PLAN SNAPSHOT REPORT BBA25-0001 FOR THE CITY OF ANN ARBOR

Description: This letter is submitted to request reconsideration of the interpretation regarding compliance with Section 1030.3 of the 2015 Michigan Building Code (MBC) as applied to Permit Number BLDGC24-0524.

RE: Request for Interpretation Regarding Permit Number BLDGC24-0524

Job Title:	
309 E. Madison Addition & Interior Renovation	309 E. Madison St. Ann Arbor, MI 48104
Sheet Title:	
Miscellaneous Details	Released For: Building Permit
05/22/2023	
JON-MAD22	
A-610

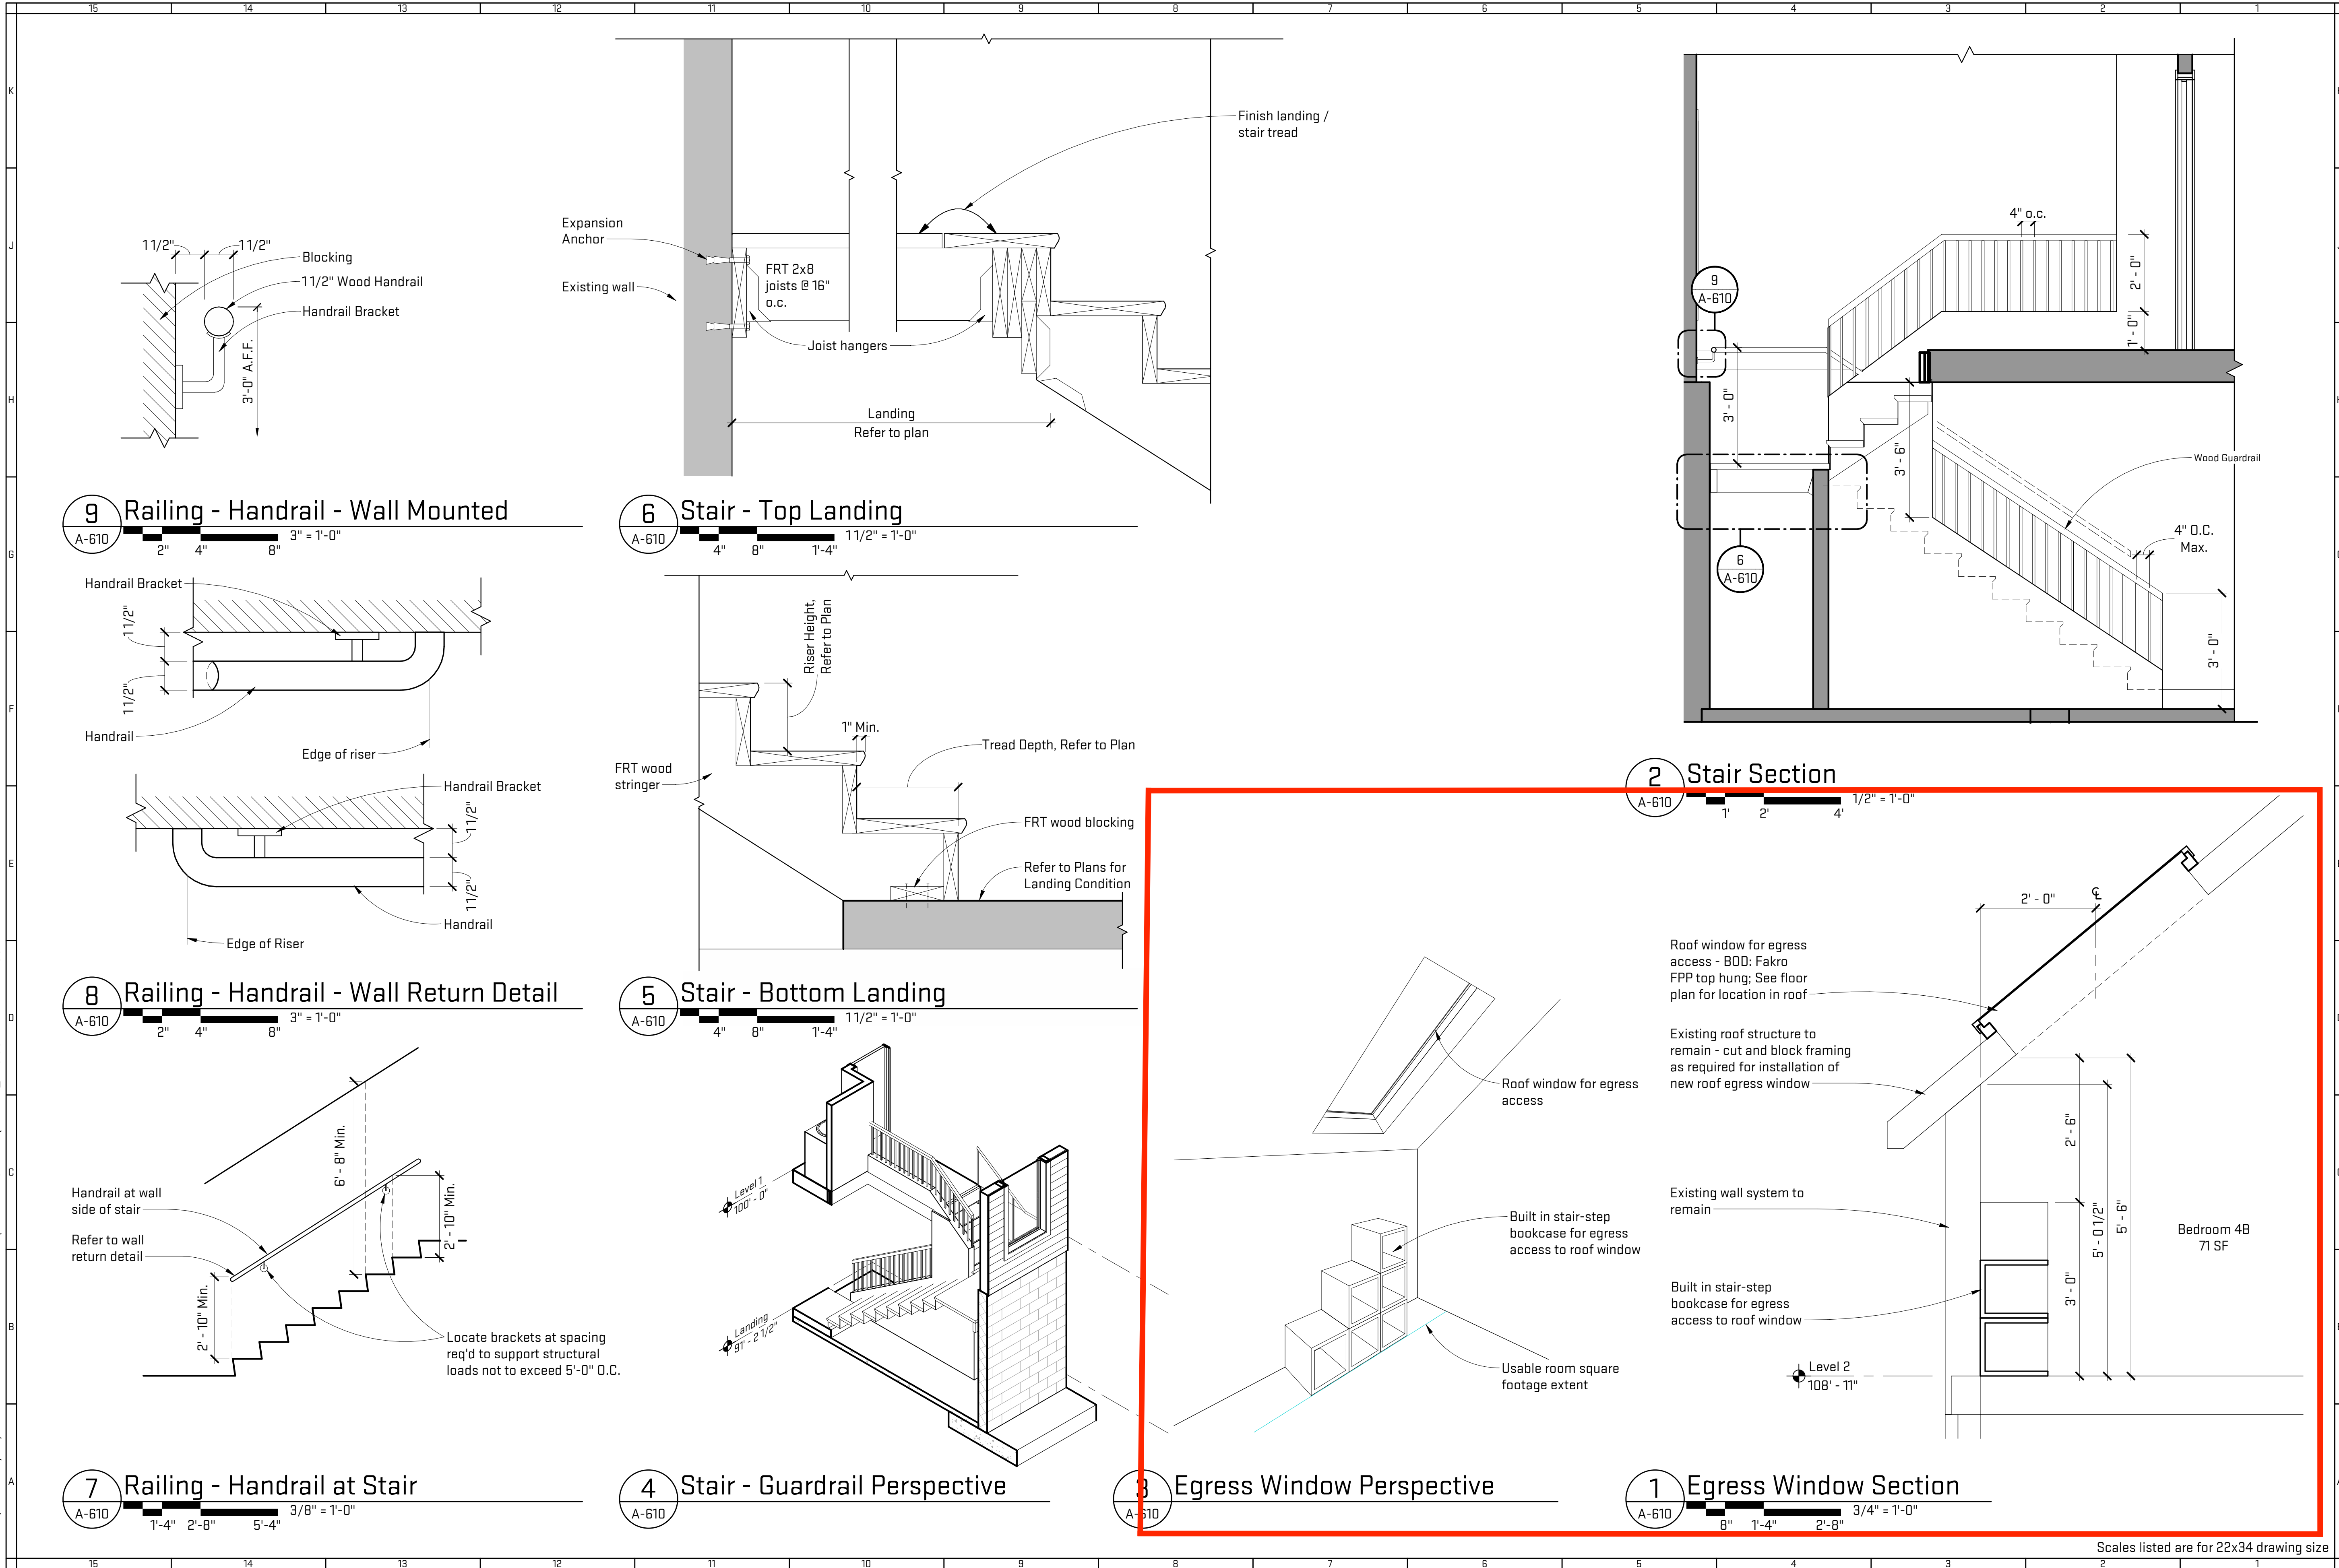
- In numerous jurisdictions, landings are accepted as the "floor" for the purposes of measuring compliance with Section 1030.3. This interpretation is supported by:
 - The functionality of landings as part of the egress system.
 - The practical need for design flexibility in situations where strict adherence to the "overall floor plate" interpretation is unnecessary and overly restrictive.
-

- Section 104.1 of the 2015 MBC grants the AHJ discretion in interpreting the code when issues are not explicitly provided for.
 - However, this discretion must align with the overall intent and purpose of the code, which prioritizes safety, accessibility, and functionality. By interpreting the landing as the "floor" for compliance with Section 1030.3, the AHJ would support the intent of the code while ensuring practicality in design.
-
